View of western portal from the new A303 PRoW

Referring to [REP7-024] 8.47 OEMP Annex 4A – Illustrated Examples of Key Design Elements

Fig 1. Photo taken from M and R Hosier field looking north to A303 (as shown by traffic at top of the picture). Illustrates the built up area.

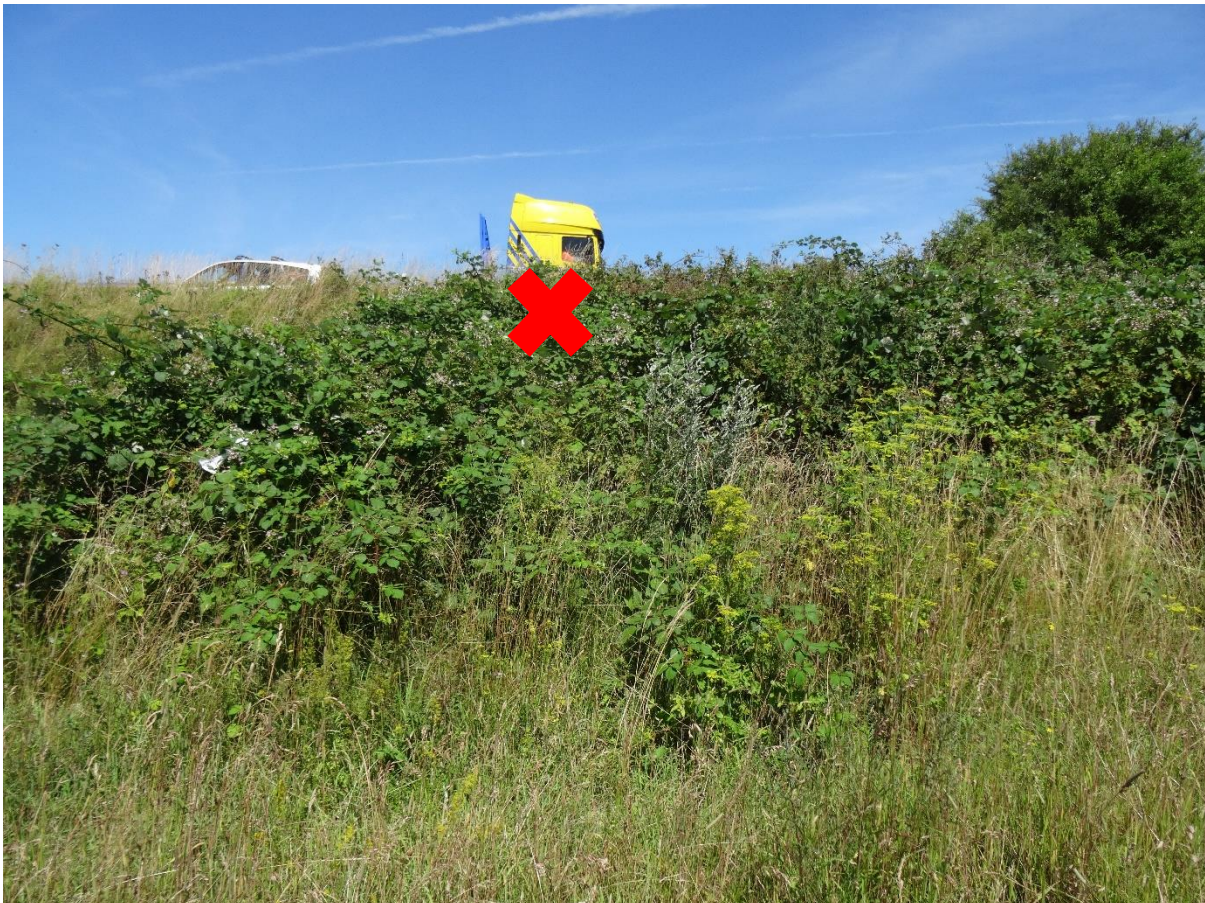
The Scheme as presented, has used the natural topography of the landscape, placing the road at the lowest point within the dry valley. However, it has not taken into consideration the topography in the location of the western portal, where the road level of the current A303 has been significantly built up from ground level in order to remove the blind dip in the road. See Fig 1. below showing the extent of the built up area of the A303.

Fig 5.

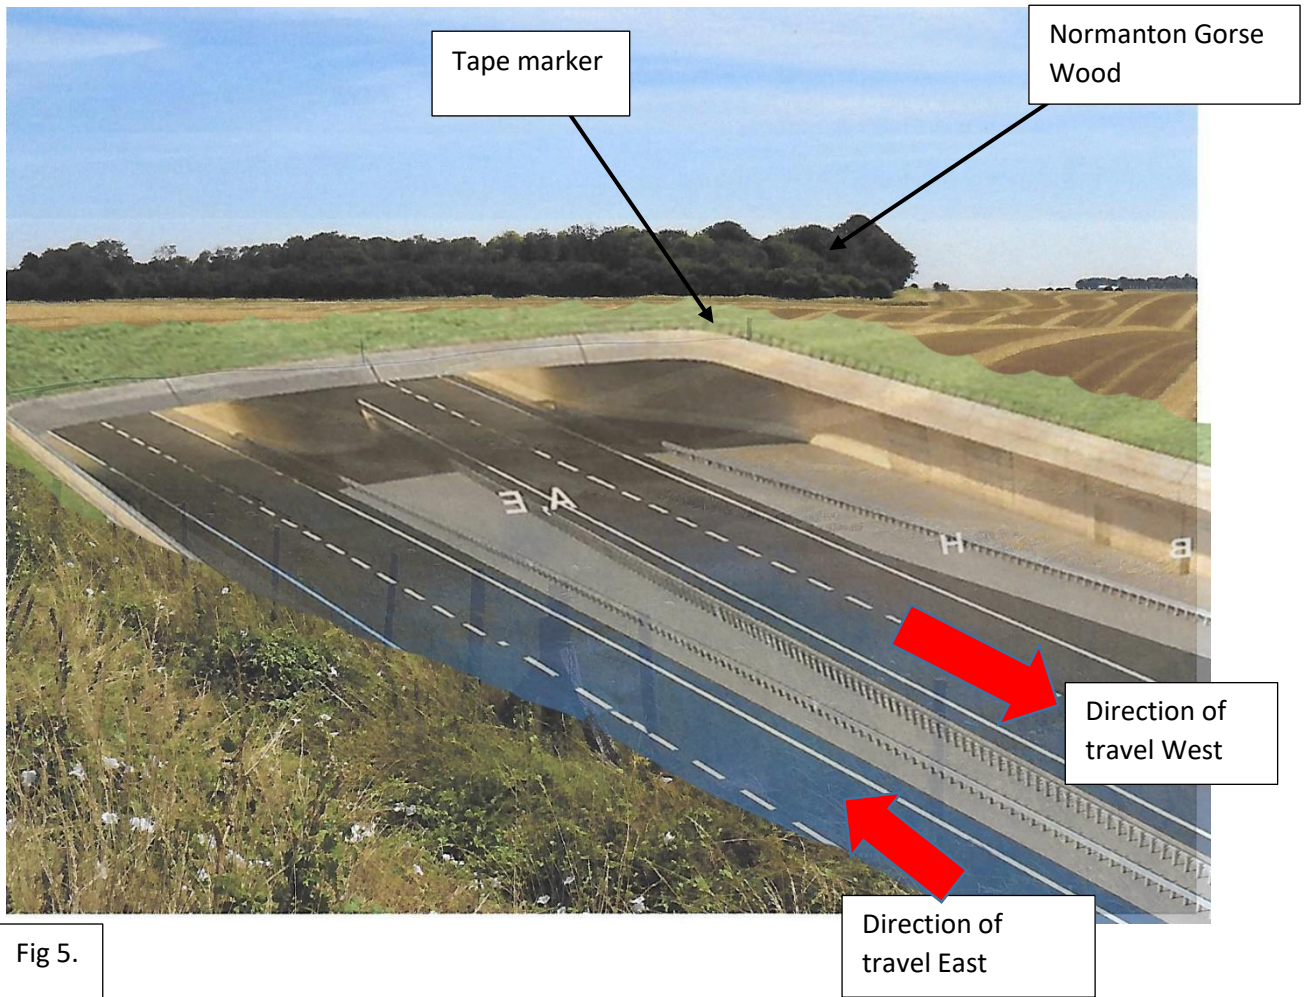
Travelling west along the verge (which will be part of the PRoW), look back to the east, there will be a view into the deep cutting which will certainly show the retaining walls. See photograph below fig 5 .

The photographs above clearly show that the design with the western portal and deep cutting within the WHS do not fall within the Scheme criteria as noted in a number of the OEMP items, eg:
